Development Review Board

TO: Development Review Board
FROM: Garret King
DATE: March 5th, 2025
RE: ZP-25-24; 17 Van Patten Parkway

Request: Proposed removal of old retaining wall to construct a new 75ft long 7.5ft tall retaining wall with a 4ft setback. And addition of gravel.

Proposed new wall location

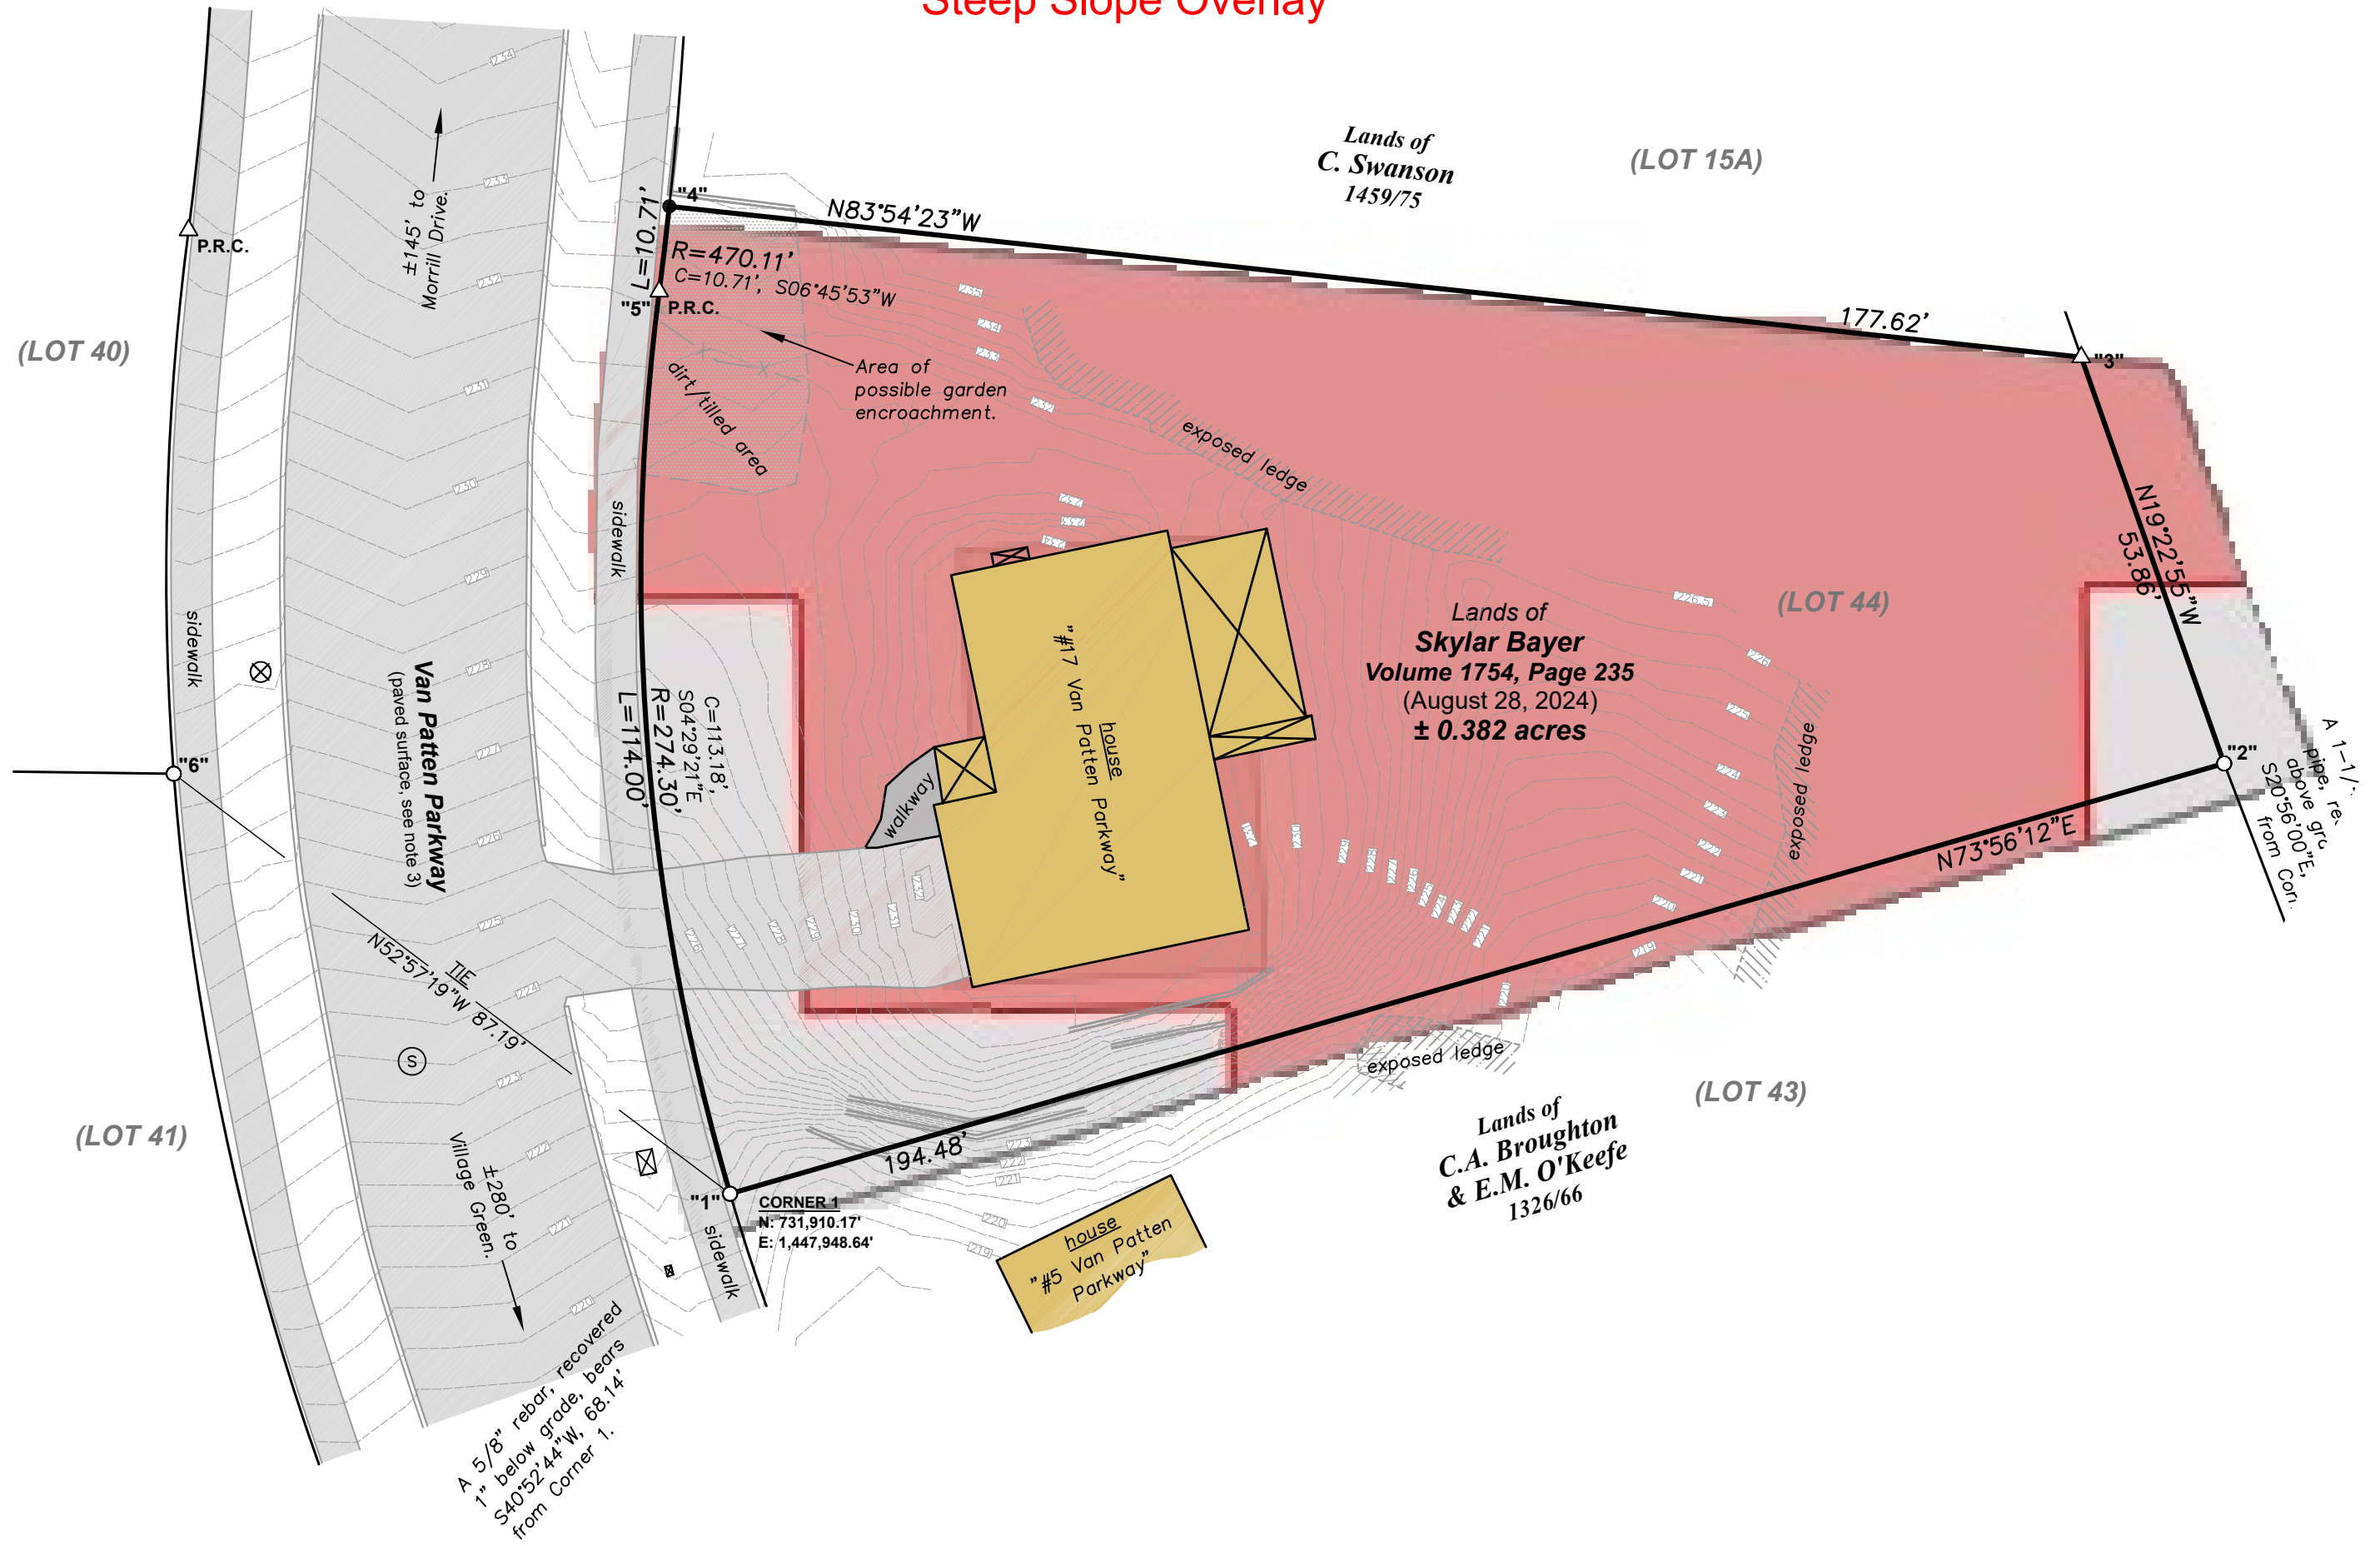
The subject property tapers from 114.3ft wide at the street down to 53.8ft wide at the rear of the property. The proposed retaining wall will encroach into the front and south side yard setbacks. The wall is proposed to be ~4ft from the property lines. Height of the retaining wall varies depending on grade but is up to ~7.5' tall. Given its height and proximity to the side property line, Development Review Board approval is required. **(Affirmative finding)**

The retaining wall is not particularly massive and does not overwhelm the site. Its exposed side faces south, toward the neighboring property. It will be set behind several trees that may provide some screening. As a bare concrete block wall, this criterion requires additional screening such as climbing vines. A revised site plan, including proposed plantings, is required. **(Affirmative finding as conditioned)**

1. **Prior to release of the zoning permit**, subject to staff review and approval, plans depicting additional plantings, such as climbing vines or shrubs, along the base of the retaining wall to better screen it from the neighboring property to the south.
2. **Prior to the start of construction:**
 - a. The applicant shall provide all required engineered drawings and plan for staff review and approval by the City Engineer to meet all stability, grading, and safety requirements.
 - b. A geotechnical analysis per Sec. 5.2.4 (b) 3. will be required.
3. Standard Conditions 1-15

Brush/Tree Removal

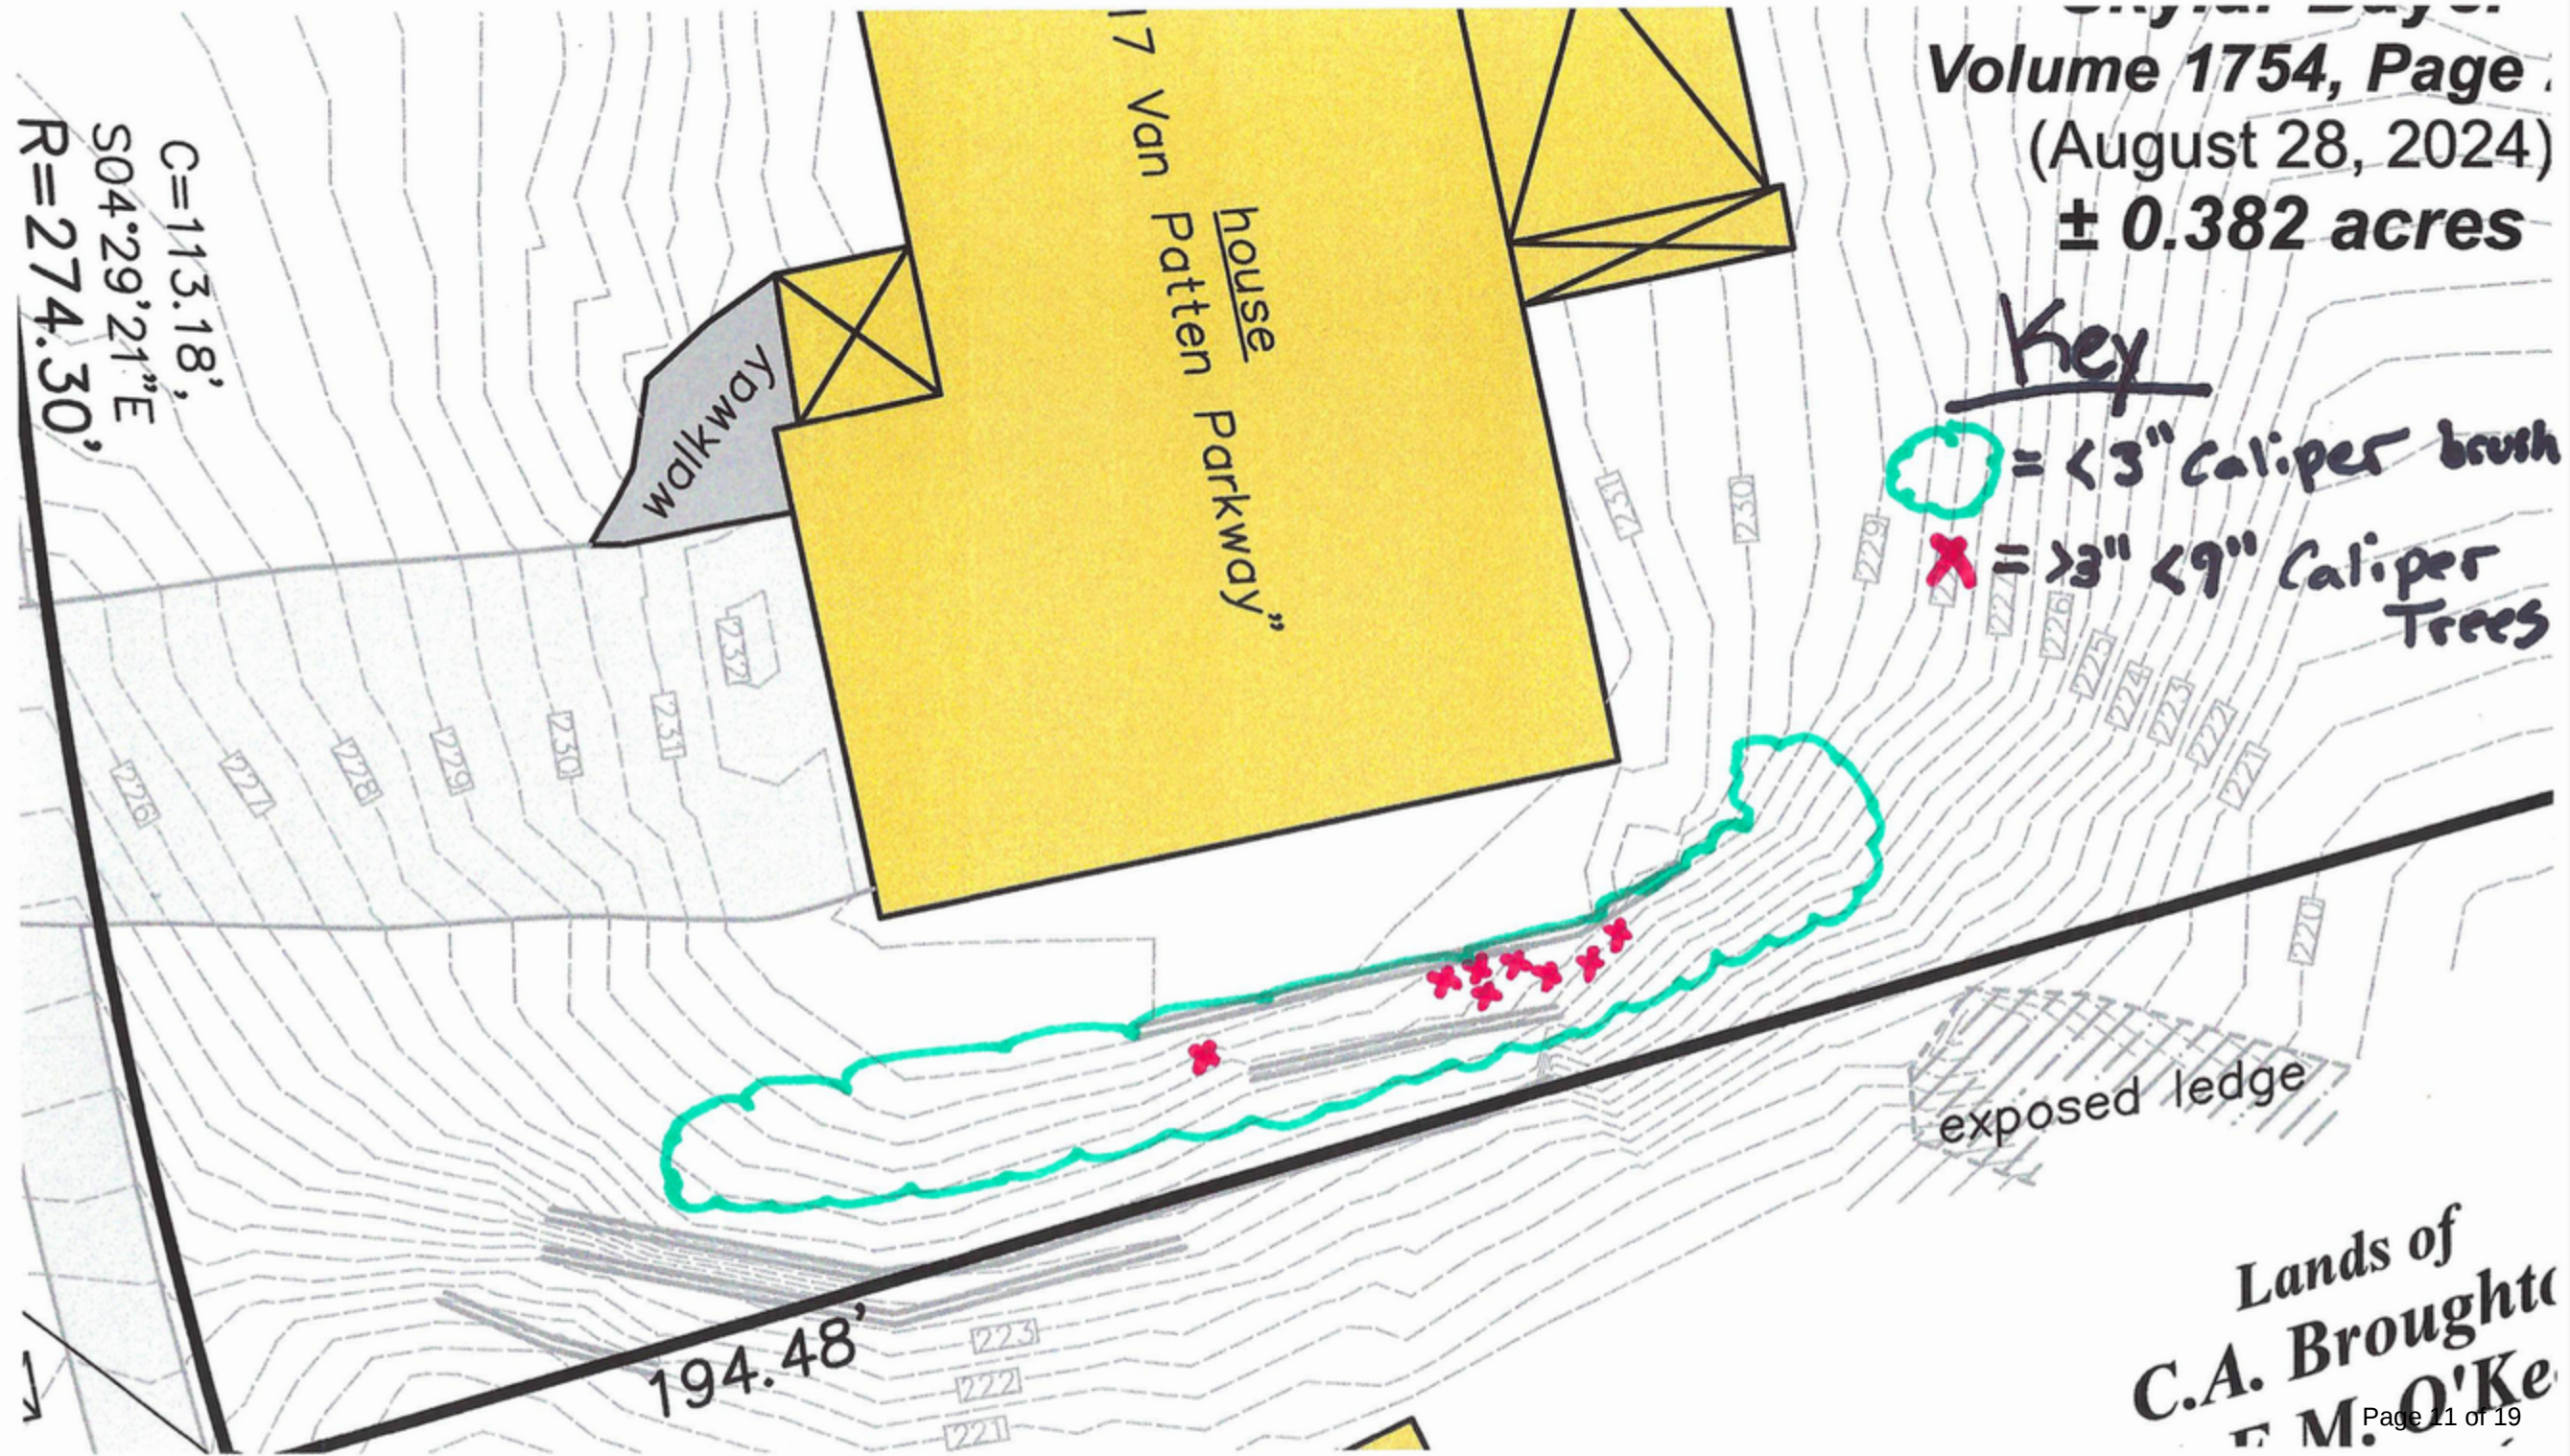
A vegetation clearing plan shows that several trees and associated shrubbery will be removed for the installation of the new retaining wall. **(Affirmative finding)**
